**BAYVIEW WELLINGTON**

SP-2017-051 BLOCK 5 PLANS  
JULY 2017 1/8" = 1'-0" drawing scale  
1

BLOCK 5

BASEMENT PLANS

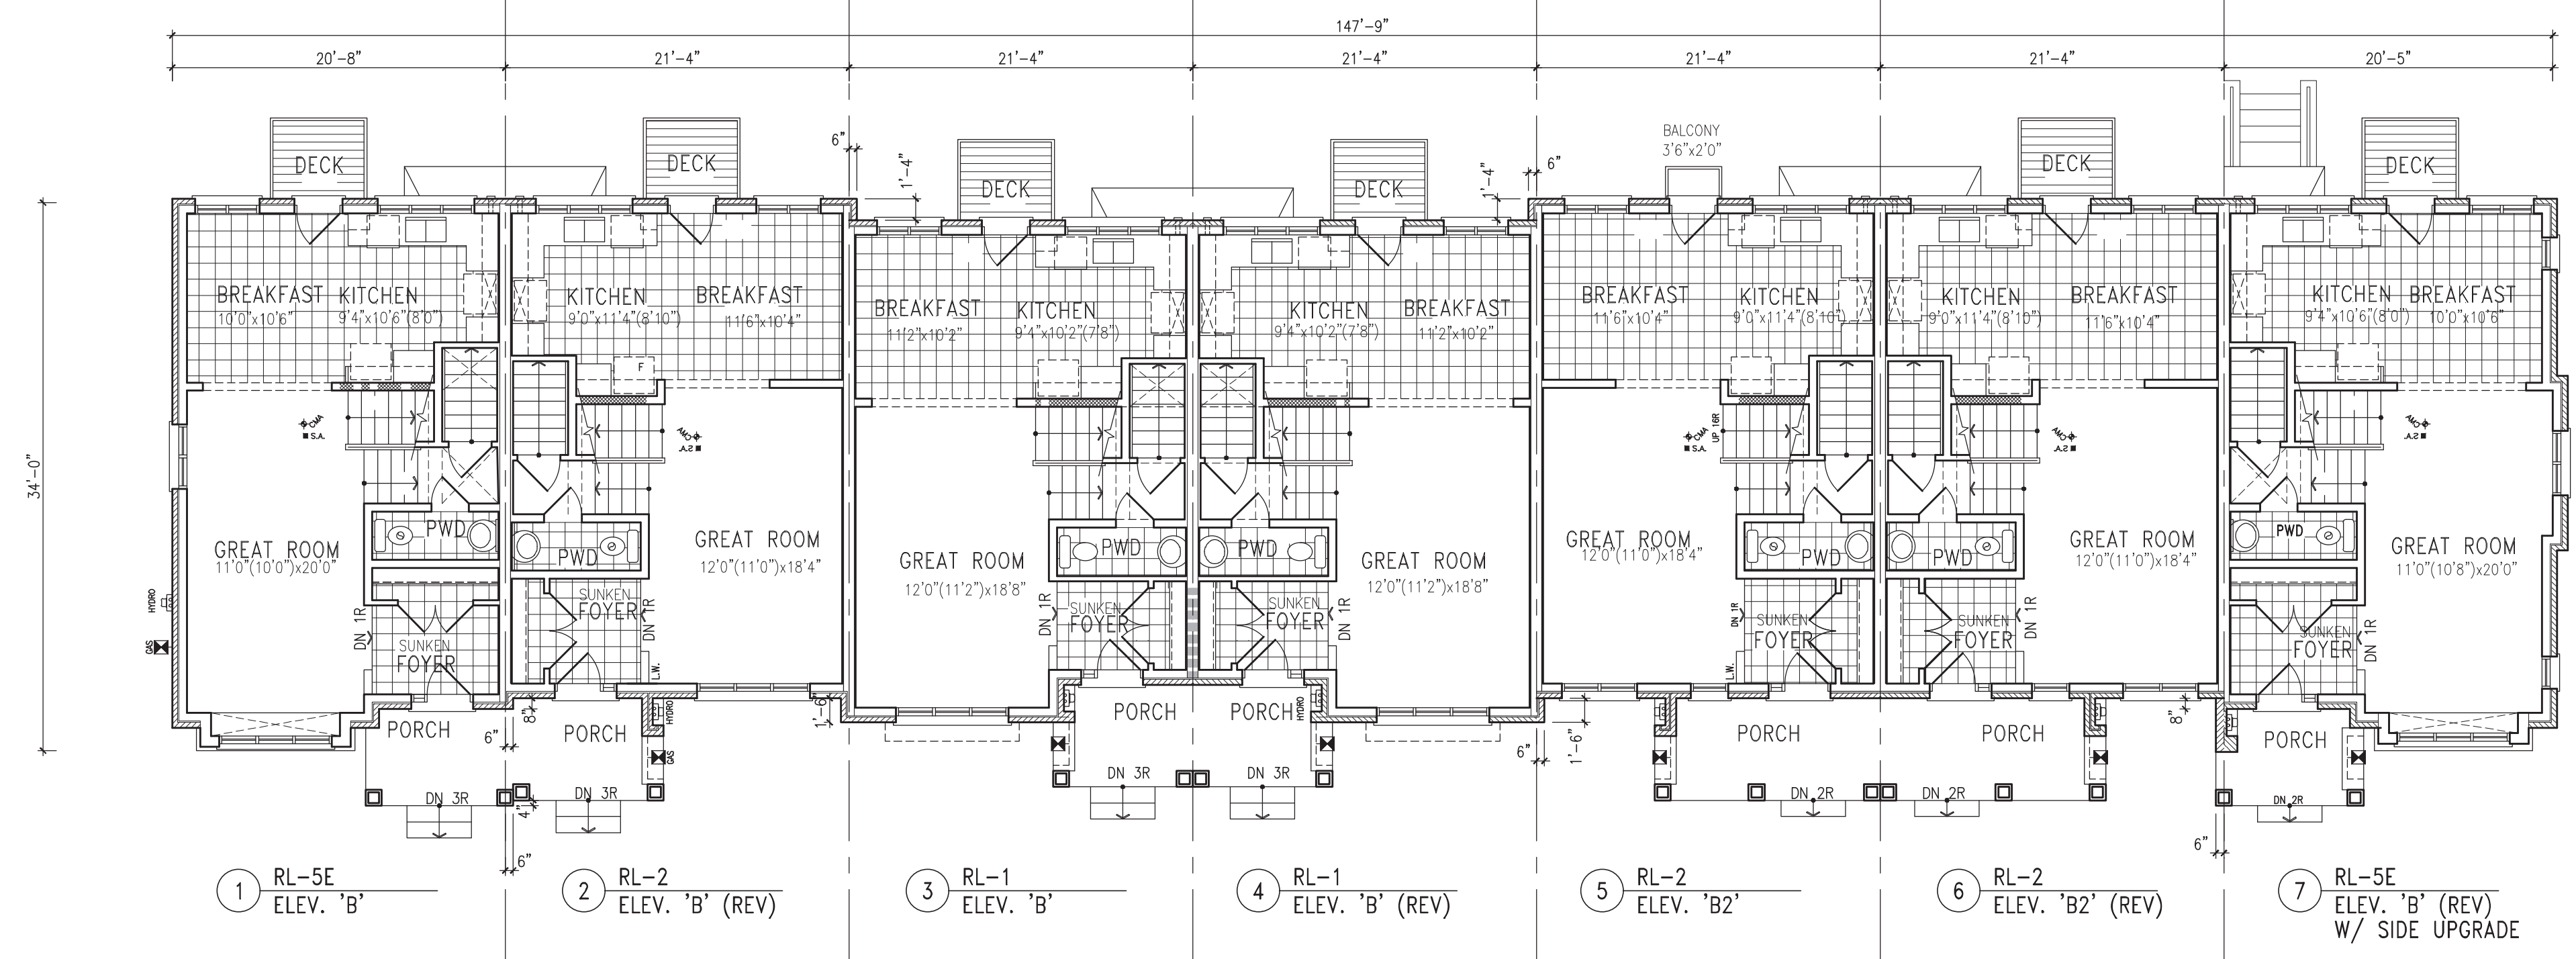
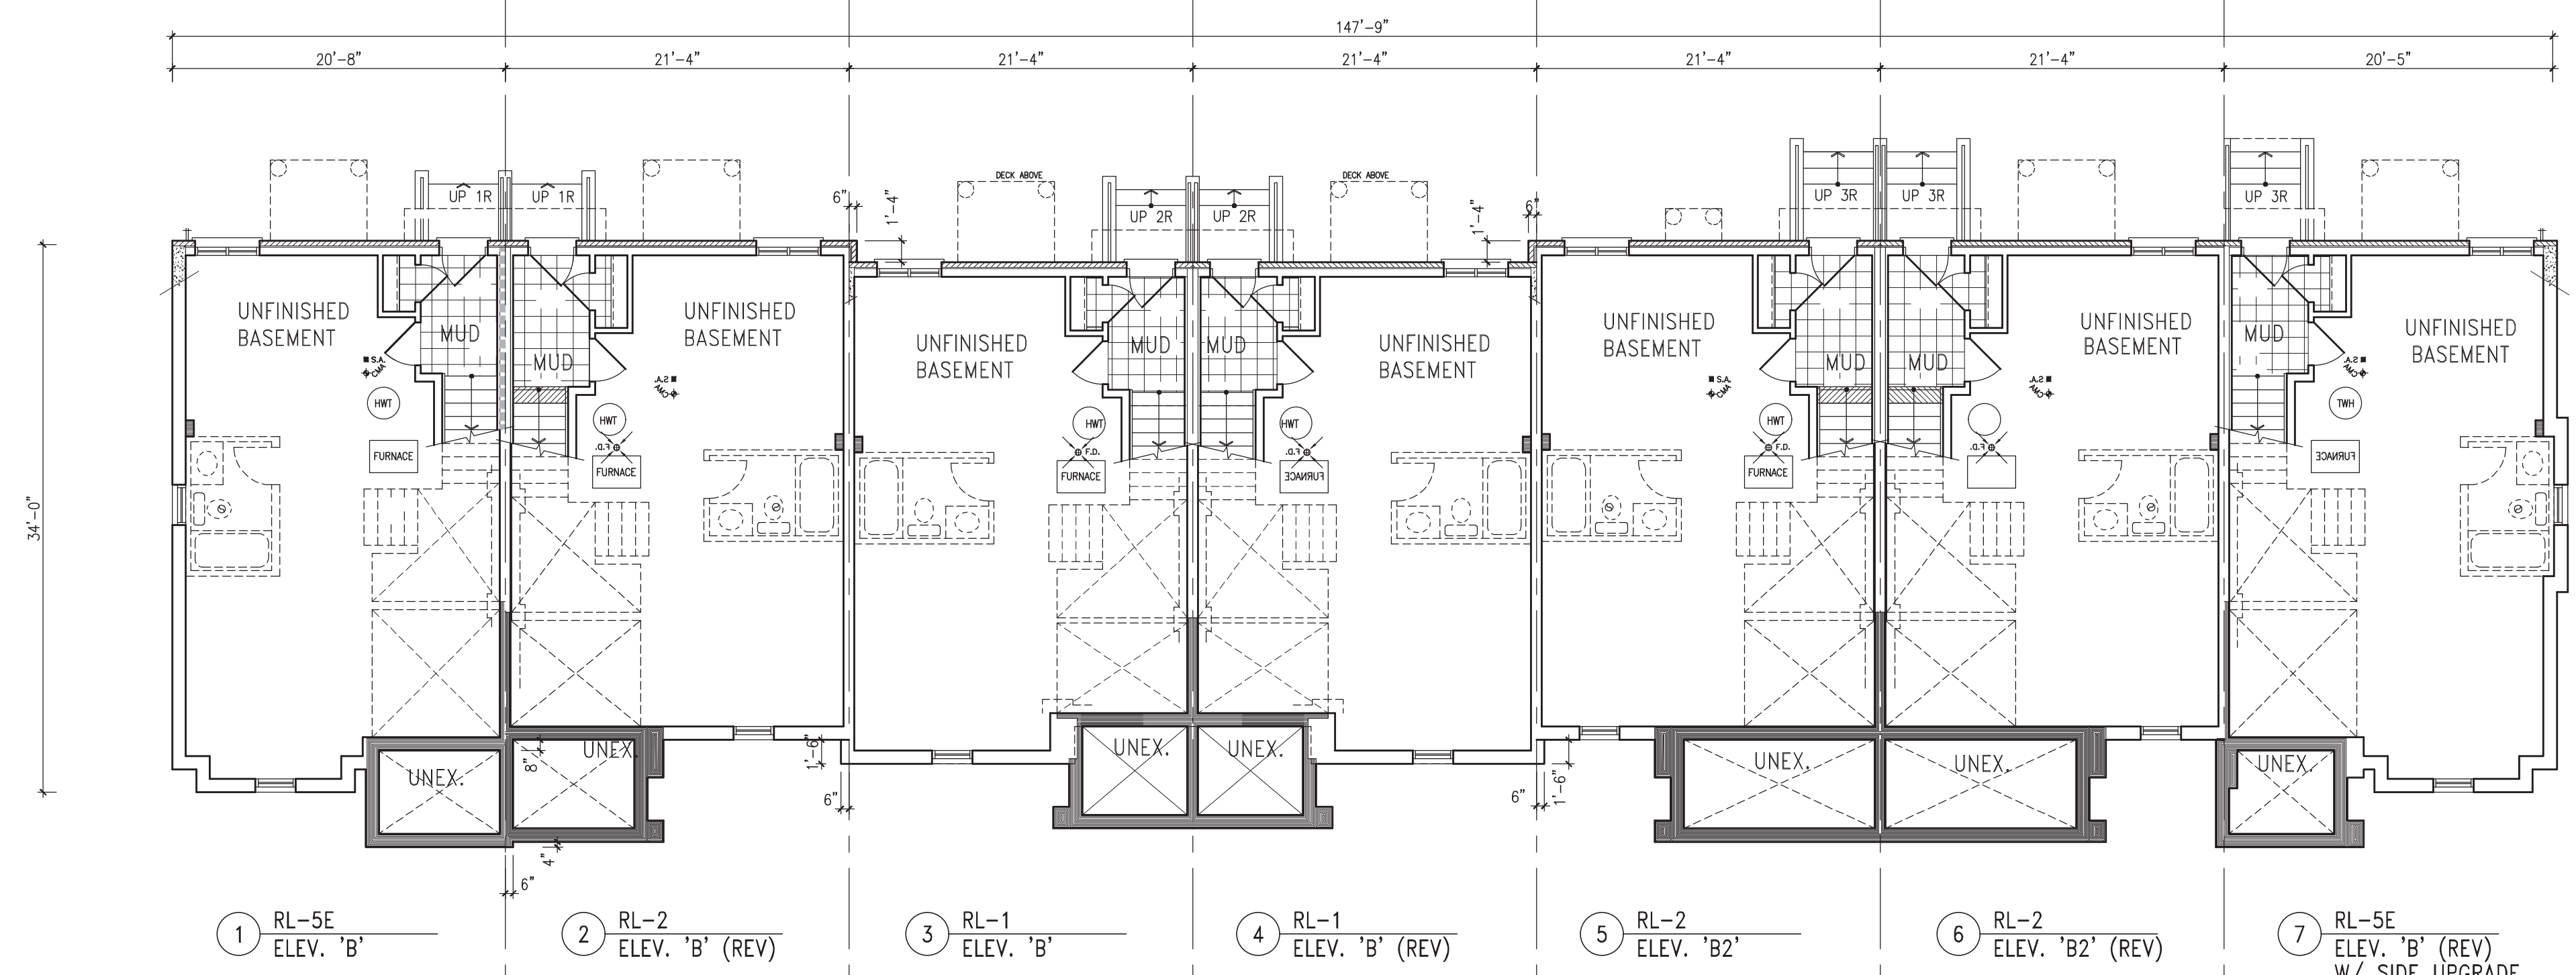
**Town of Innisfil Building Dept Notes:**

All smoke alarms and CO detectors shall comply with O.B.C 9.10.19 and 9.33.4

Main bathroom shall be designed as per 9.5.2

All construction subject to review by Town Building Inspectors

See comments on permit
